Mask Set Errata for Mask 2L47P

This mask set errata applies to the mask 2L47P for these products:

- MC68HC908AP64
- MC68HC908AP32
- MC68HC908AP16
- MC68HC908AP8

Figure 1. Typical ADC Error Count

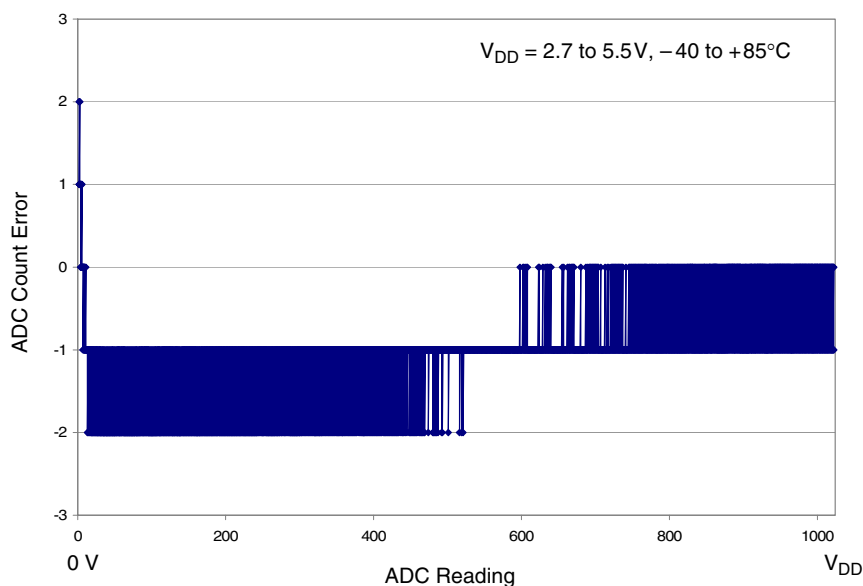
The 10-bit ADC conversion result for 0V input (zero input reading) is \$000, \$001, \$002, or \$003; not the specified \$00 or \$01. With inputs of 5mV and above, the ADC is within the specified accuracy of ± 1.5 LSB (see [Figure 1](#)).
